# City of Frankfort

To: Architectural Review Board  
From: Jordan Miller, Senior Planner  
Re: Meeting – August 18, 2020

ARCHITECTURAL REVIEW BOARD

416 Capital Avenue  
Special Capital Historic District

Jeff Raine, Architect

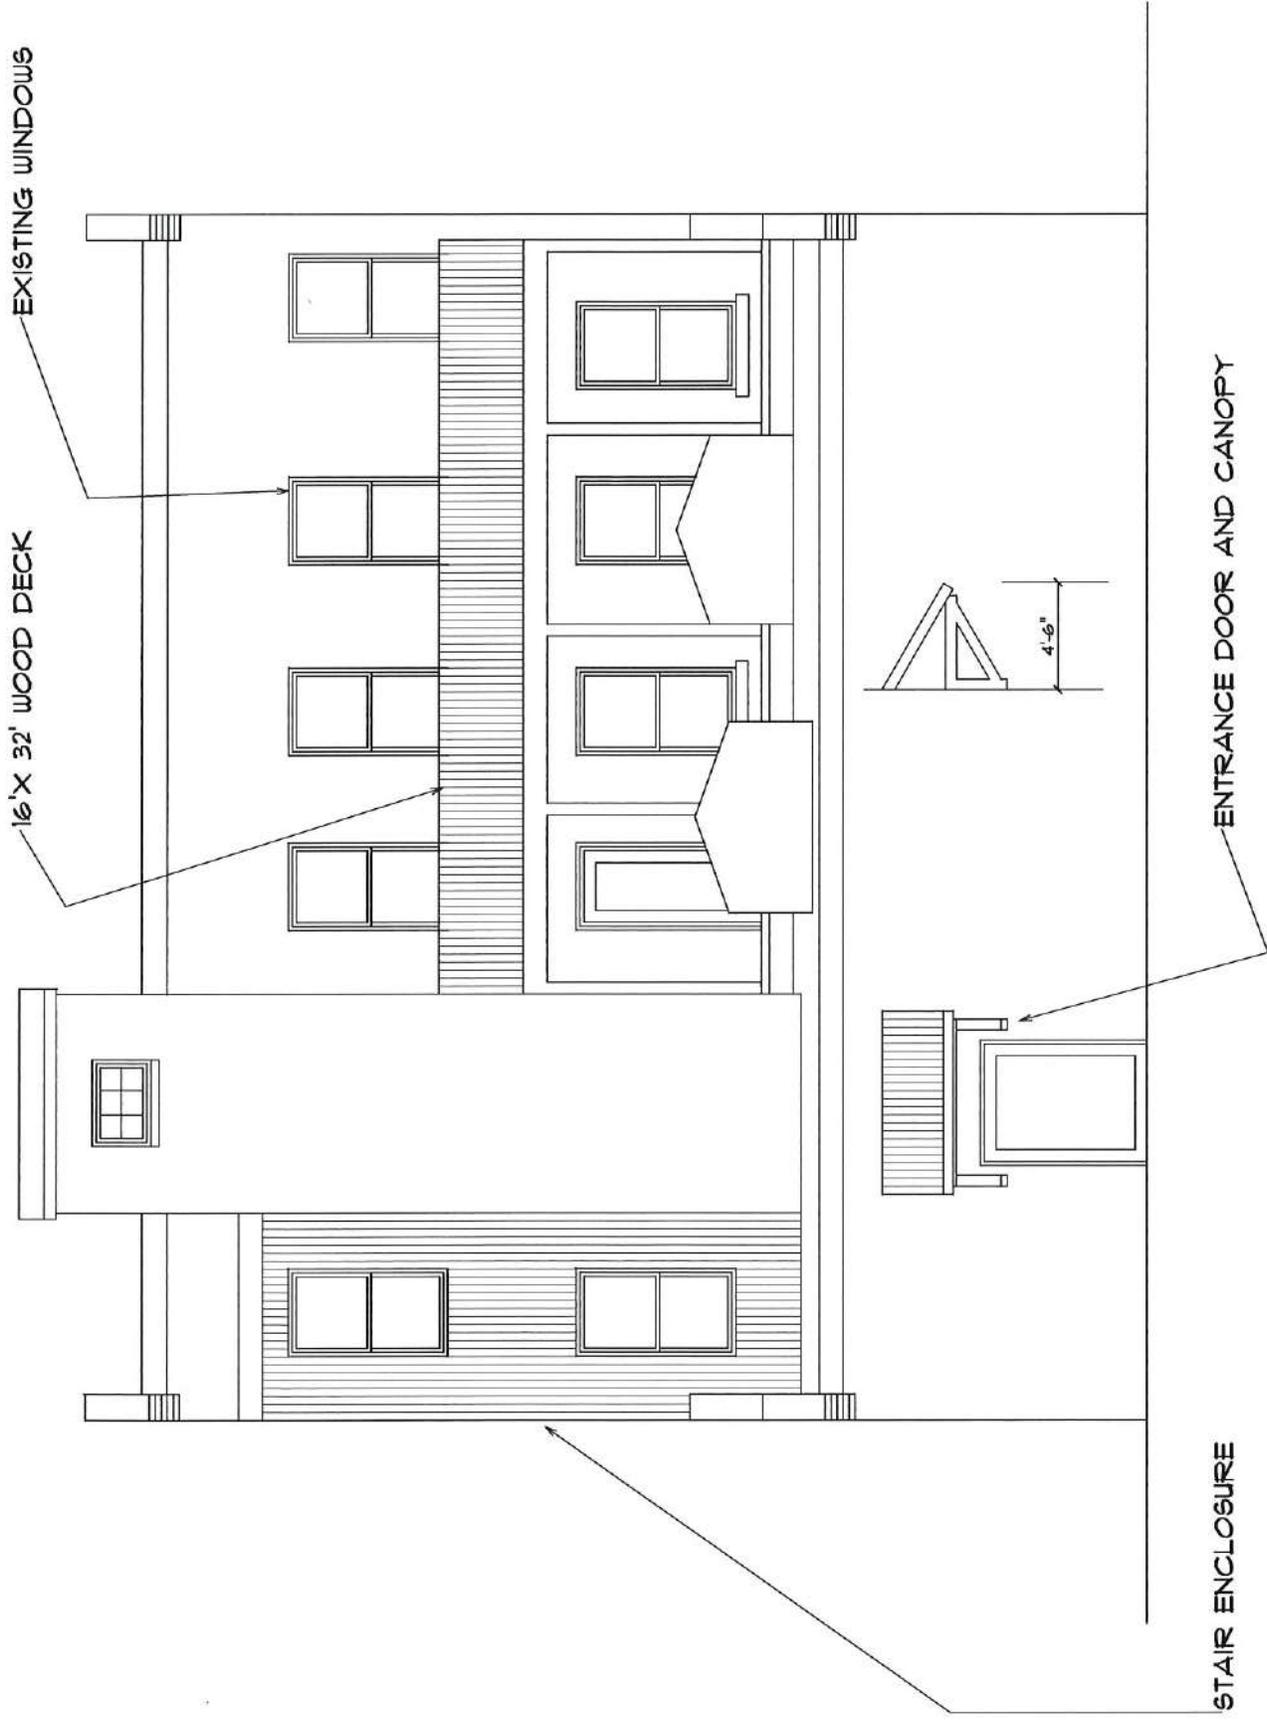
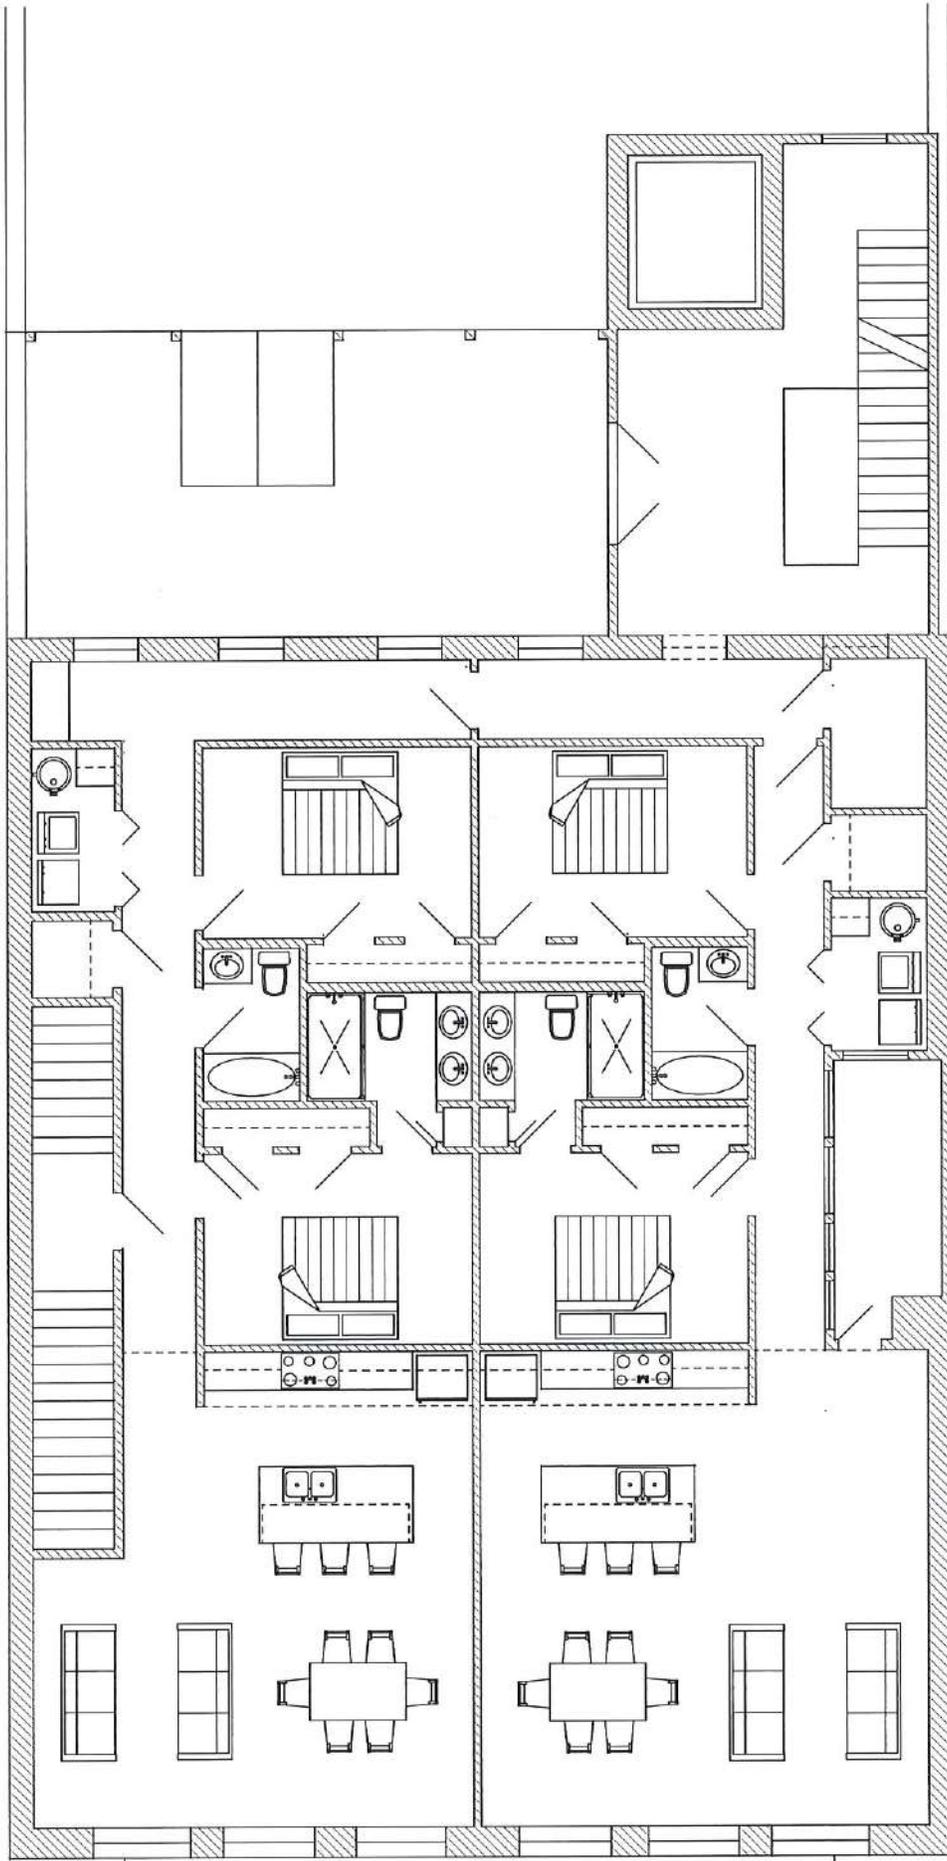
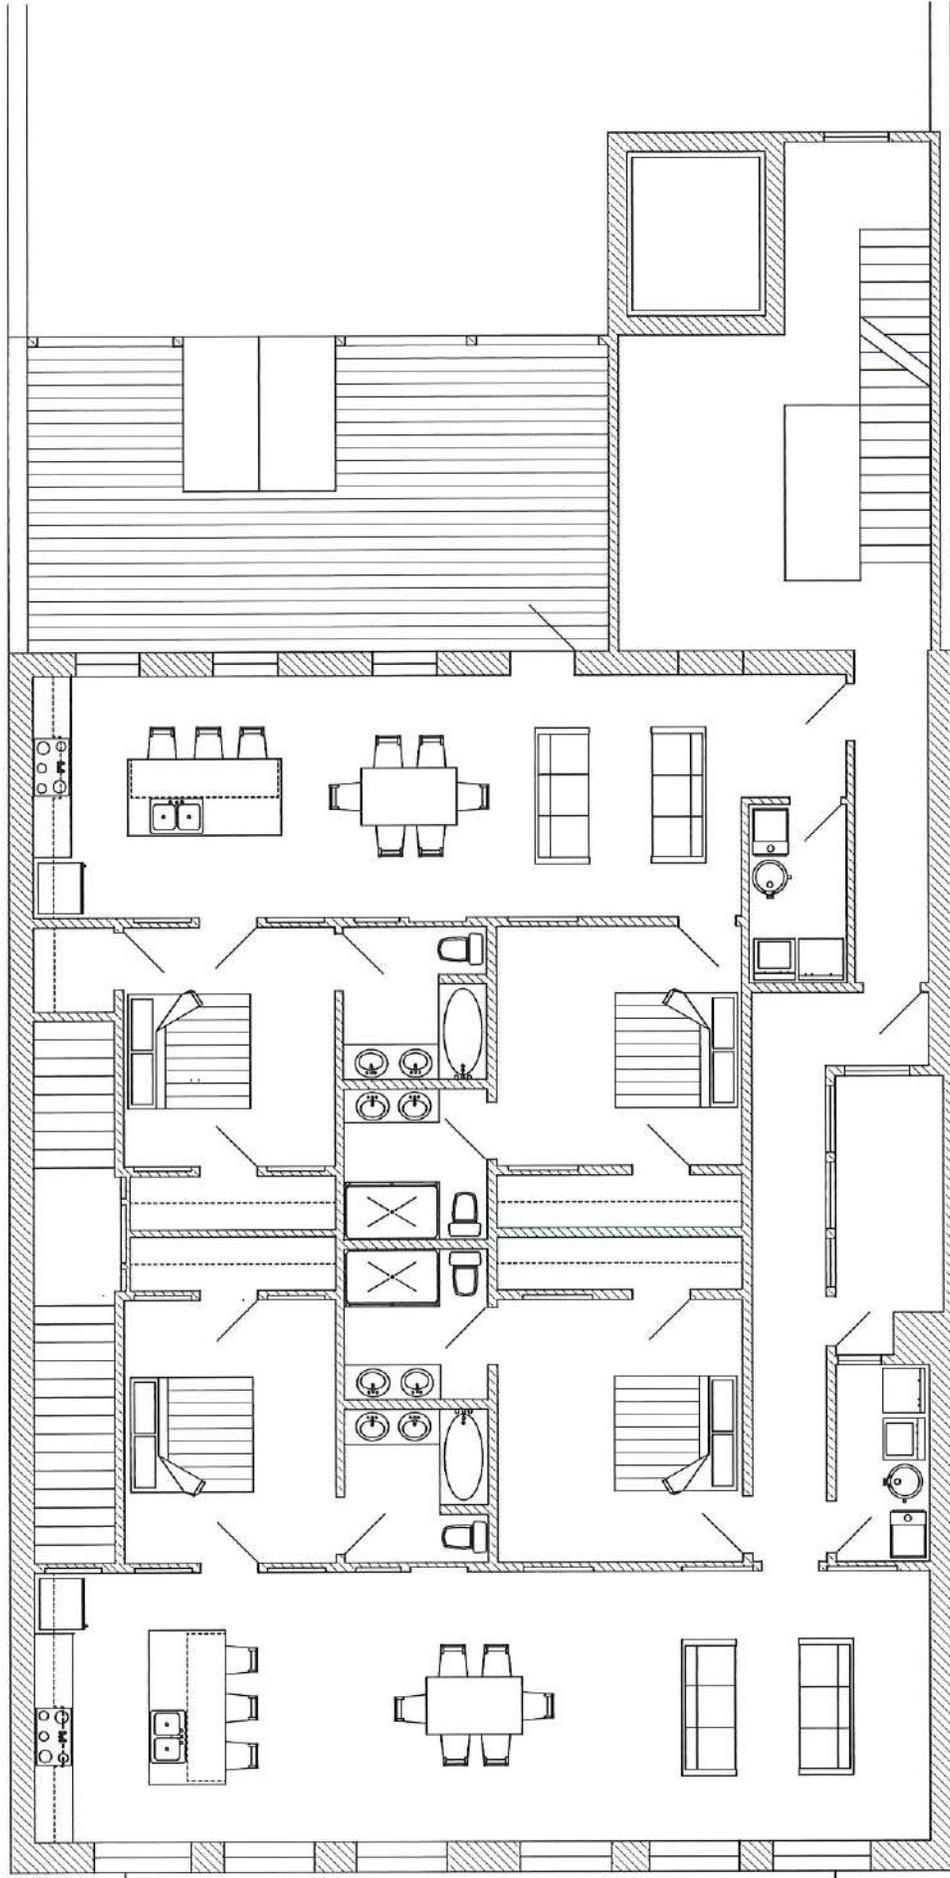
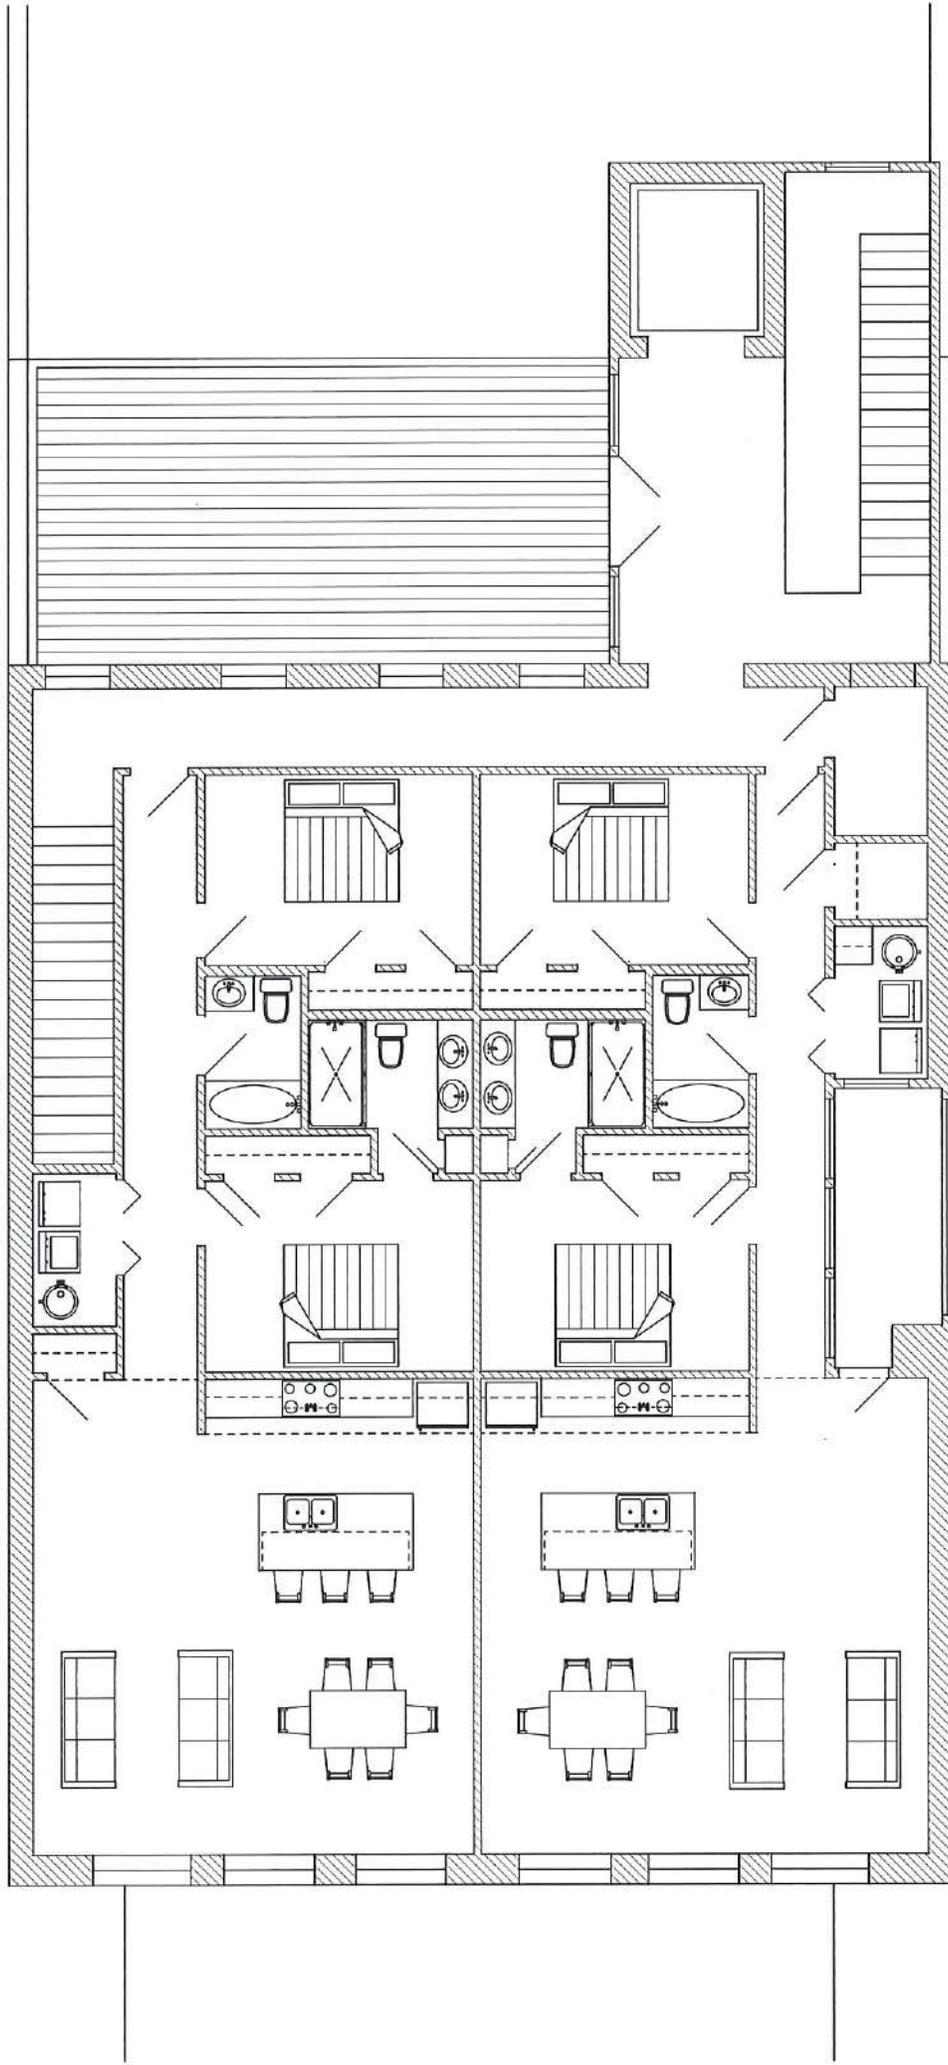
*Staff finding: Positive. The stair enclosure will feature single hung wood windows that provide fenestration that reflect the existing rear façade.*

*Staff finding: Positive. The stair enclosure will stand out as a product of its own time by featuring a sheet metal exterior covering that is different from the existing brick and reflects the existing sheet metal currently found on the building.*

*Staff finding: Positive. The stair enclosure will feature single hung wood windows that provide fenestration reflecting the proportion, size, and rhythm of those on the original building*

*Staff finding: Positive. The proposed sheet metal is compatible with existing materials on the building and is also used in the district to some extent, but primarily as a roofing material.*

1. A building permit shall be obtained prior to work commencing on the proposed project.
2. Any additional projects requiring a building permit or modifications to this proposal shall require review and approval by the Architectural Review Board unless a Certificate of No Exterior Effect is issued.
3. The construction of this request shall conform to the design and drawings found within this report.

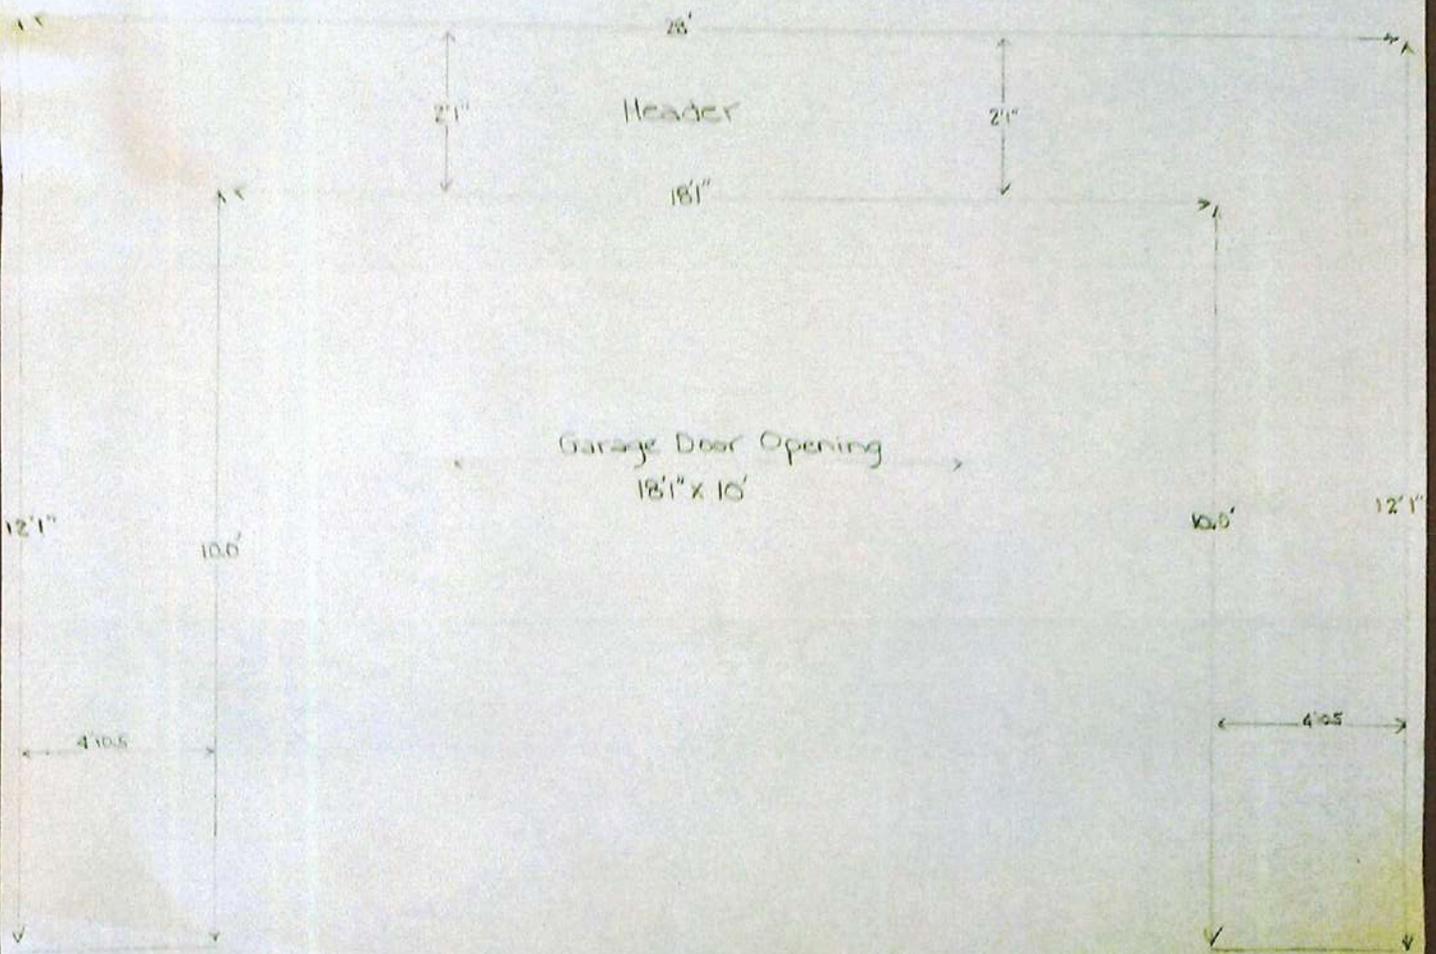
Staff has positive and negative findings for the request. The door opening will be partially filled in on the front façade, however it is non-functioning and finding a replacement door and parts of this type today would be difficult as it is a non-traditional size and design. This building was initially used as warehouse and storage for the adjacent building's furniture business, which is has not been active for several decades. The existing door will remain in place and the opening could be returned to its original size relatively easily in the future if that were desired. The existing I-beam located above the existing door will remain and will help to break up the directional expression of the building façade. Furthermore, this is not a contributing property to the district and Staff finds that this modification will not negatively affect the overall integrity of the district.

1. A building permit shall be obtained prior to work commencing on the proposed project.
2. Any additional projects requiring a building permit or modifications to this proposal shall require review and approval by the Architectural Review Board unless a Certificate of No Exterior Effect is issued.
